# Groundwater Application Review Summary Form

Application # G 19139

TO: Water Rights Section Date 7/10/2023  
 FROM: Groundwater Section Joe Kemper  
 Reviewer's Name  
 SUBJECT: Application G- 19139 Supersedes review of 08/12/2021  
 Date of Review(s)

**A. GENERAL INFORMATION:** Applicant's Name: Kameron DeLashmutt/Pinnacle Utilities, LLC  
 County: Deschutes

Figure 3. Water-Level Measurements of Groundwater Elevations Across the Deschutes Regional Groundwater System

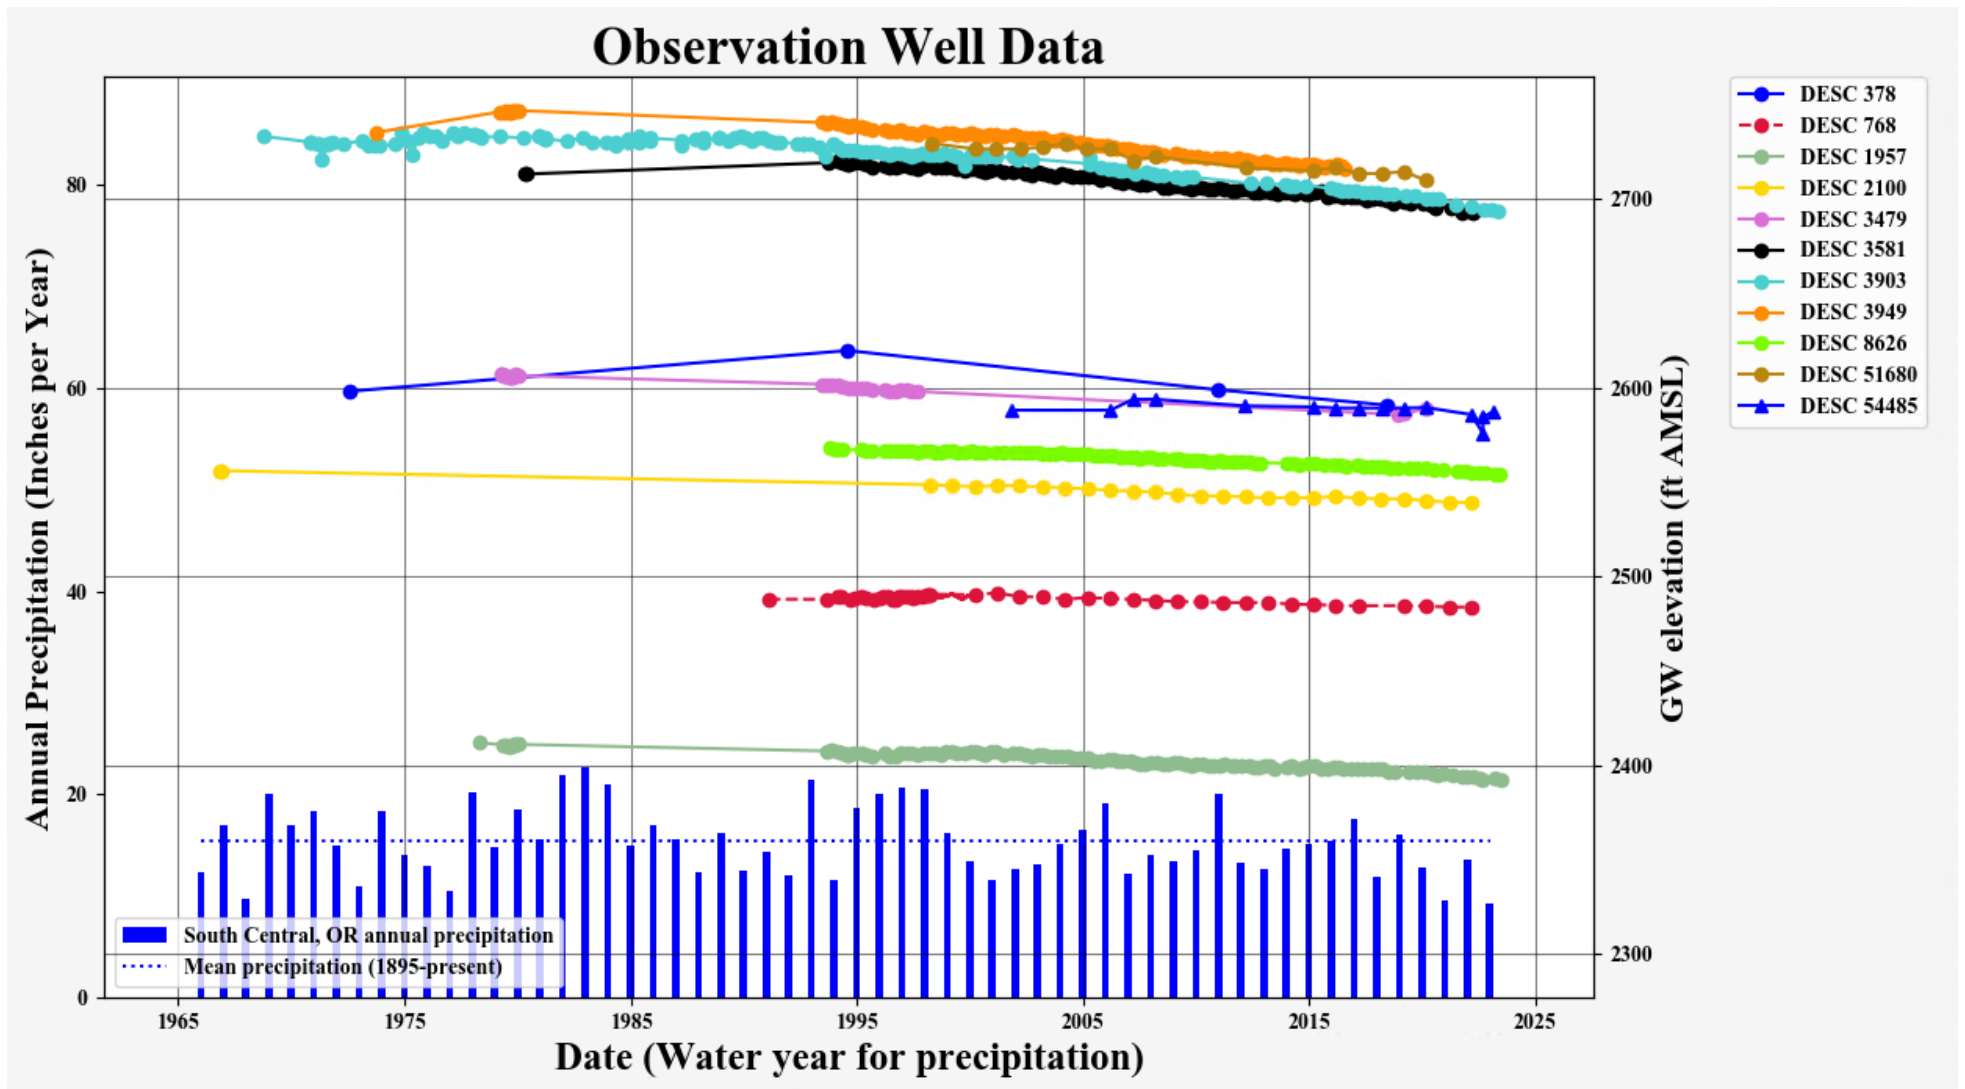
The Sisters Fault Zone (SFZ) is a NNW-trending series of mapped faults that extend from Black Butte to Newberry Volcano. The SFZ is coincident with the steep recharge gradient in the Cascades and may slow groundwater flow from the Cascades towards the basin lowlands. Wells upgradient (southwest) of the SFZ show large decadal fluctuations that track with climatic cycles but do not show year-on-year declines beyond those climate cycles (e.g. DESC 3016). Climate

recharge appears to diminish from SW to NE across the SFZ as year-on-year declines increase from DESC 2929 to DESC 1957 and DESC 8626 in the Lower Bridge area.

In the basin lowlands from the SFZ to the Deschutes and Crooked Rivers confluence, nearly all long-term observation wells show continuous and significant year-on-year water level declines since the mid-1990s. The rate of decline increases steadily from the Lower Bridge area to the Bend-Redmond-Powell Buttes area. Since 1994, wells in Lower Bridge area have declined 12-14 feet, wells near Cline Buttes have declined 15-25 feet, wells between Bend, Powell Buttes, and Redmond have declined 33-38 feet (see Figure 5). Figure 5 also shows that water level declines in the Redmond area have accelerated from 1 ft/yr between 2004 and 2019 to 2 ft/yr from 2019 to 2023. Within the Redmond-Bend-Powell Buttes area where declines are the steepest, one well (DESC 5045) has exceeded more than 50 feet of total decline. A USGS report by Gannett, et. al., (2013) estimated that, of groundwater declines in the area between Cline Buttes and Redmond through 2008, 60-70% are caused by climate influences, 20-25% are due to increases in pumping, and 5-10% are caused by canal leakage reductions. The available data indicates that these stressors on the groundwater system have persisted or increased since that report was published.

Figure 4. Water-Level Measurements of Groundwater Elevations Adjacent to Cline Buttes and Redmond

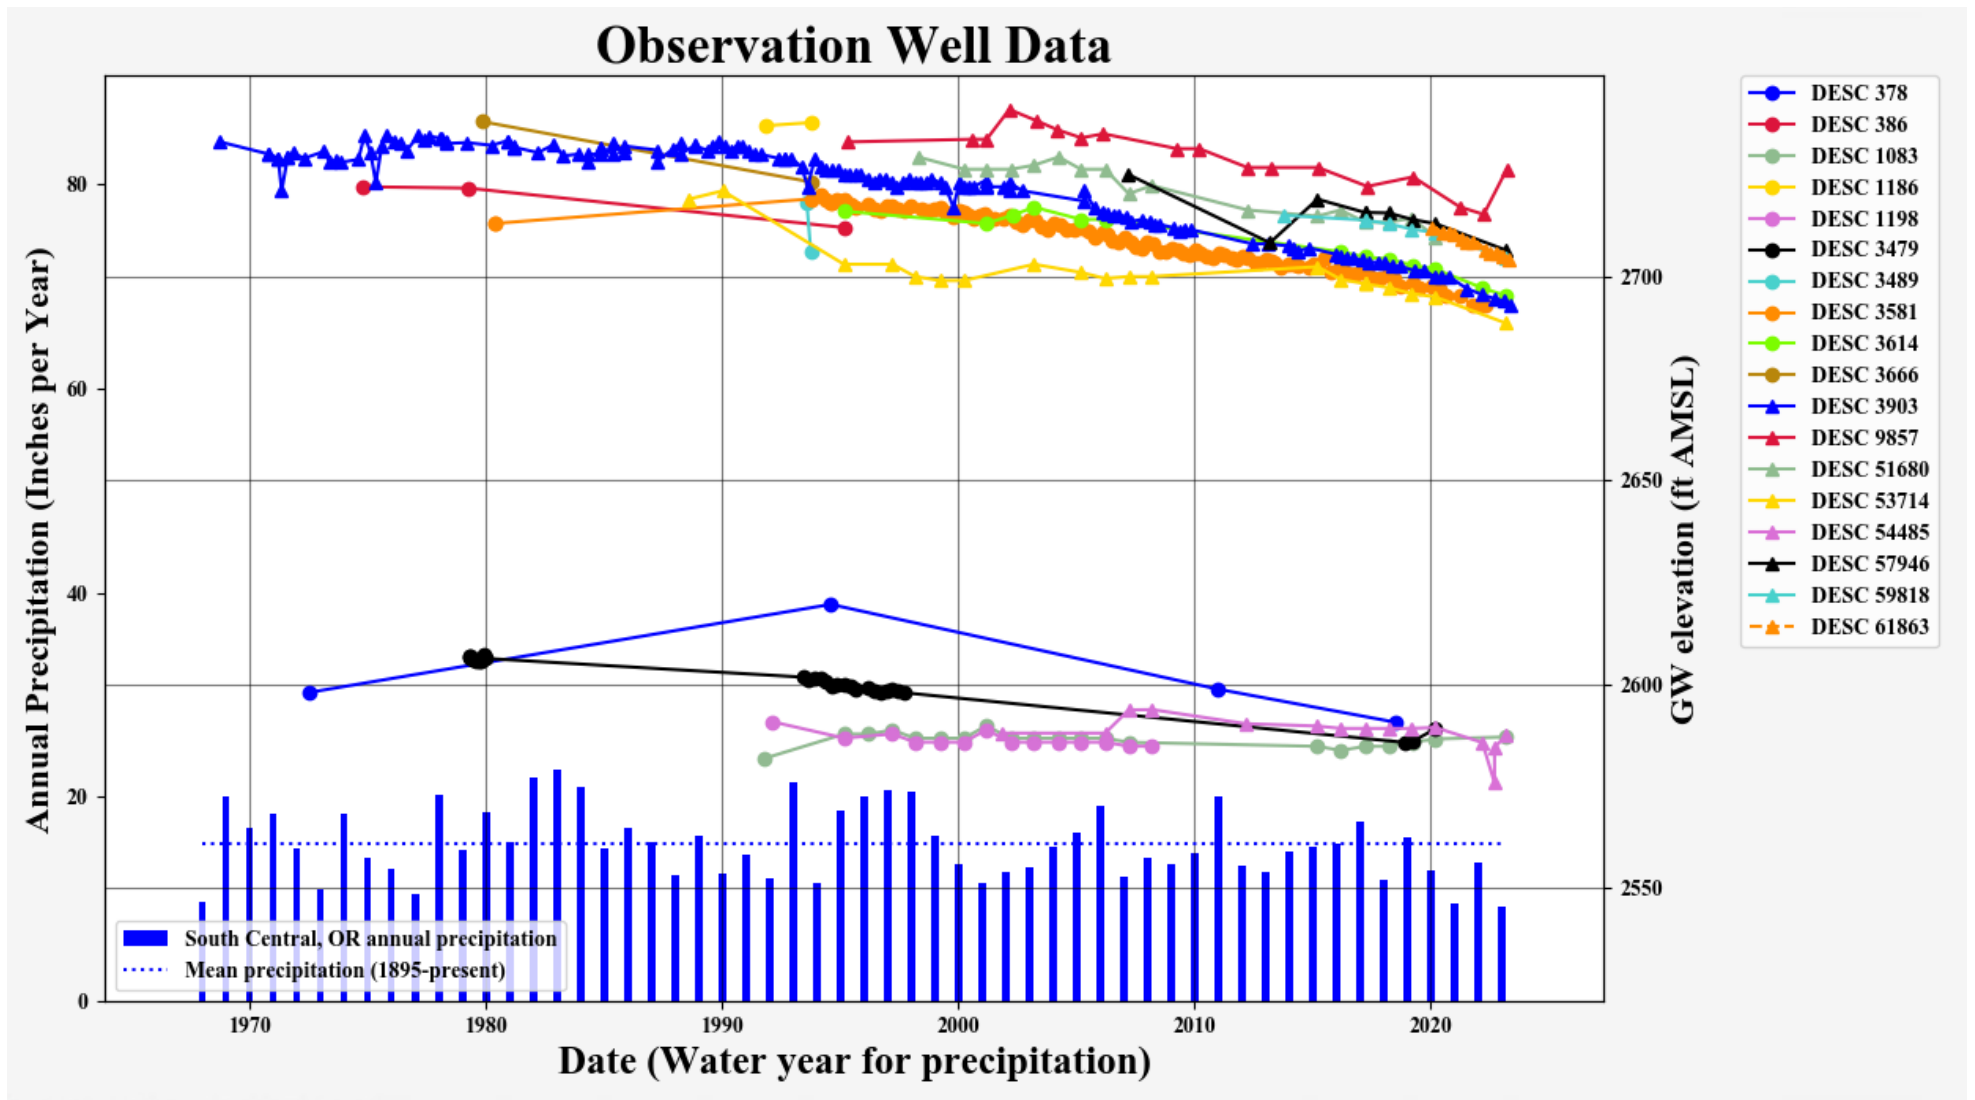
The applicant's proposed wells are located in the Cline Buttes area that does exhibit some local hydrogeologic heterogeneity. Cline Buttes consists of an intrusive rhyolite dome (TdrCb in Sherrod et al., 2004) that interrupts the laterally extensive volcanics of the Deschutes Formation. Water level elevations in wells immediately adjacent to Cline Buttes cluster around 2570-2590 feet amsl, and water level elevations east of Cline Buttes through Redmond cluster between 2690-2710 feet amsl. There is a steeper hydraulic gradient between those two groups of wells that is roughly coincident with the Cline Buttes rhyolite contact. Because the applicant's wells are not yet constructed, there is some uncertainty about the exact hydraulic conditions that they will encounter (e.g., the 2570-2590 feet amsl cluster or the 2690-2710 feet amsl cluster). However, they will still be accessing the Deschutes regional groundwater system NE of the SFZ which, as noted above, has seen persistent year-on-year declines since the mid-1990s.

There are some conflicting water level trends within the wells immediately adjacent to Cline Buttes (DESC 378, DESC 1083, DESC 1198, DESC 3479, and DESC 54485). DESC 1083 and DESC 1198 have a stable water level trend, while DESC 3479 shows year-to-year declines since the mid-1990s. The measurements at DESC 3479 were taken by OWRD or USGS staff using e-tapes, which provide sufficient precision to demonstrate seasonal and interannual fluctuations. The measurements at DESC 1083 and DESC 1198 are airline measurements submitted to satisfy permit conditions, but these measurements are considered less reliable because of a history of mechanical failures in the airline system. Due to the higher reliability of the e-tape measurements at DESC 3479, it is concluded that DESC 3479 is most representative of groundwater level trends around Cline Buttes. Considering that water levels in the Deschutes regional aquifer system surrounding Cline Buttes have shown consistent declines since the mid-1990s (see Figure 5), it is far more likely that groundwater levels within the Cline Buttes area are trending downward with the rest of the adjacent groundwater system.
